AT A REGULAR MEETING OF THE DEVELOPMENT REVIEW COMMITTEE OF THE COUNTY OF JAMES CITY, VIRGINIA, HELD IN THE BUILDING E CONFERENCE ROOM AT 4:00 P.M. ON THE 30th DAY OF OCTOBER, TWO THOUSAND TWO.

**SP-85-01 Greensprings Apartments & Condominiums
Staff Report for the November 26, 2002, Development Review Committee Meeting**

**S-63-02 & SP-88-02. Colonial Heritage, Phase I, Section 2
Staff Report for the November 26, 2002, Development Review Committee Meeting**

**Agency Review Comments
for
S-63-02 & SP-88-02. Colonial Heritage, Phase I, Section 2**

SP-122-02. Jamestown High School Parking Lot Expansion

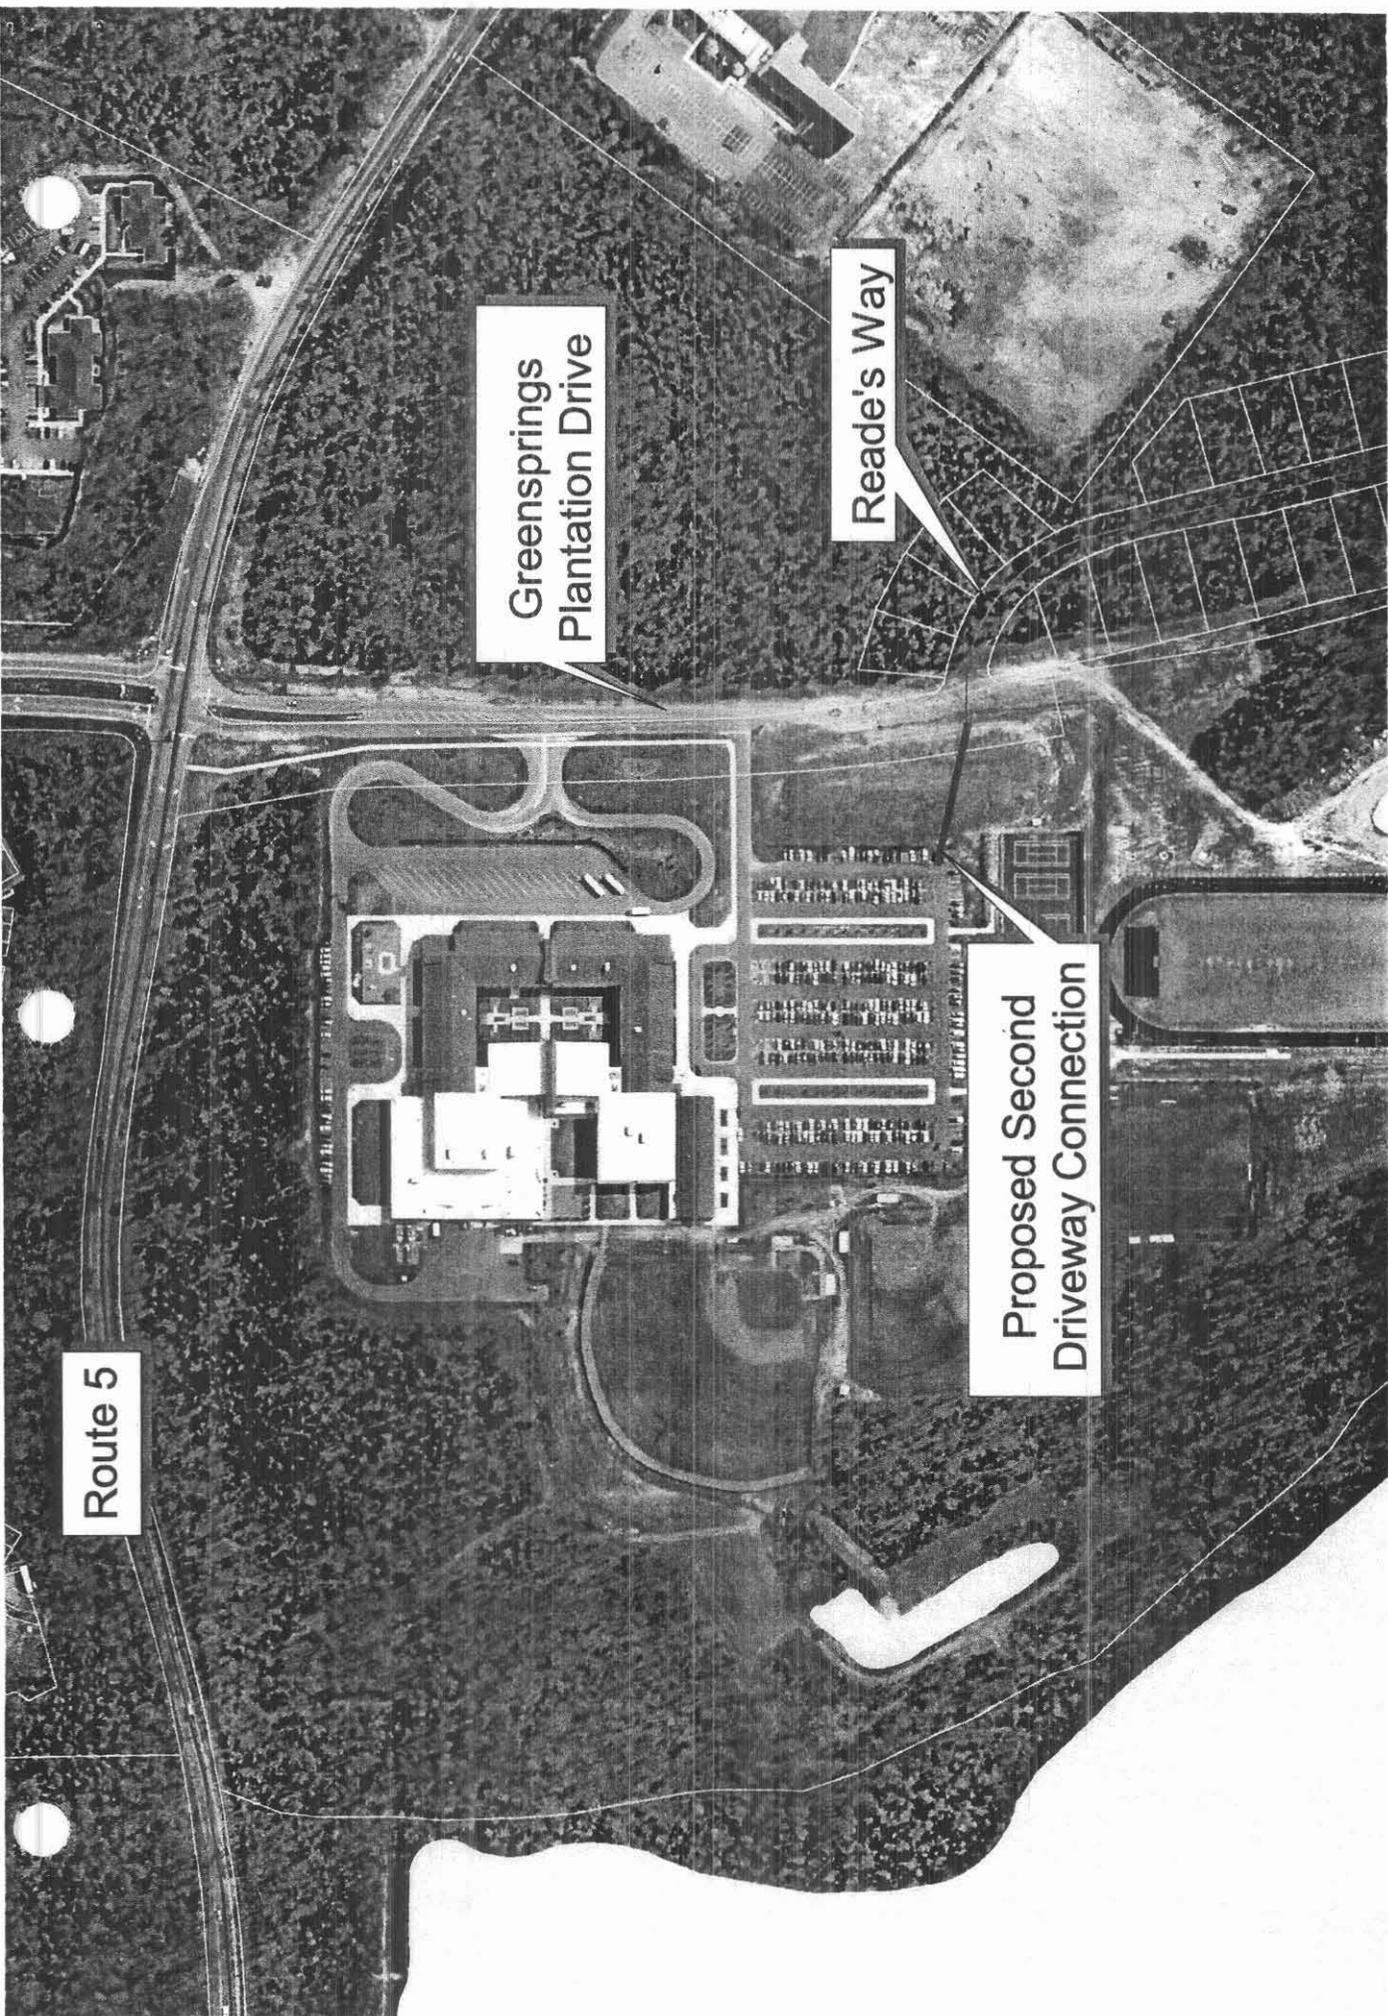
The potential second entrance into the parking lot will align with Reade's Way, the only other road on this portion of Greensprings Plantation Drive; a portion which sees very little traffic. In addition, this portion of the road is not a major collector or through road. Staff believes the second entrance will have little to no impact on the functionality of the road to accommodate traffic and recommends approval of the entrance subject to final site plan approval by the Virginia Department of Transportation and other County agencies.

Case No. S-022-02, George W. Roper II Subdivision

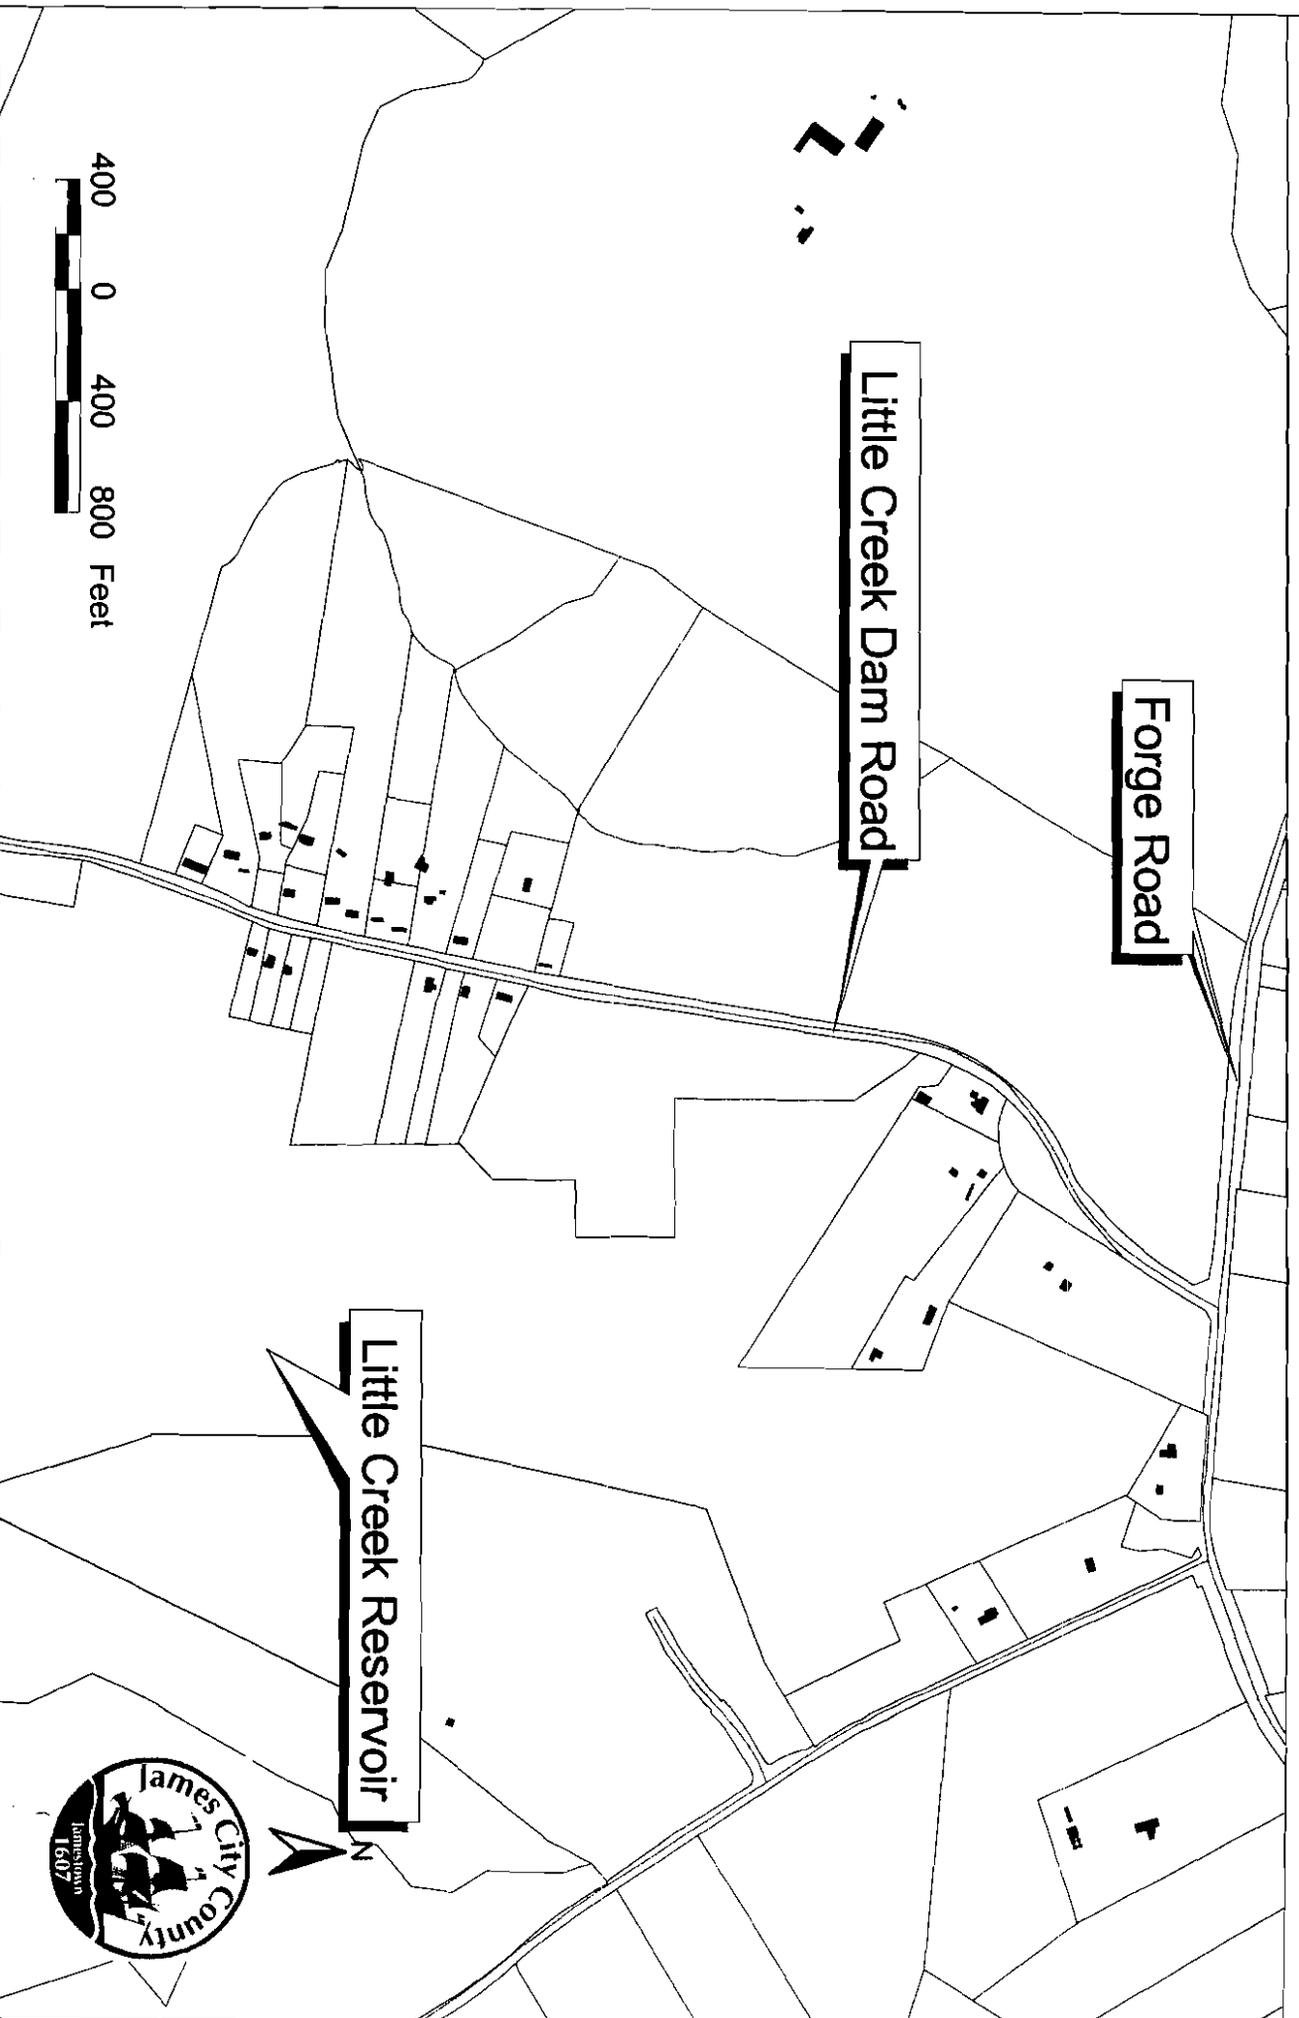
Staff does not oppose the placing of a separate access driveway for Lot 1. The combined lot frontage of Lots 1 and 2 is in excess of 1000 feet. The construction of a shared driveway to Lot 1 would satisfy the criteria for an exception as an injustice created because of property of unusual character due to its dimension.

Lot 5, for which a separate driveway is proposed, does not meet the criteria necessary for granting an exception to the subdivision ordinance. Principally, the Lot 5 portion of the parcel is not of an unusual character with regard to its dimensions, topography or other extraordinary situation or condition. Staff believes that the shared driveway for Lots 2, 3, and 4 should also include an extension to Lot 5.

Staff recommends approval for an exception to the shared driveway requirement to permit a separate driveway for Lot 1.

Staff, however, recommends denial of an exception for a separate access driveway for Lot 5.
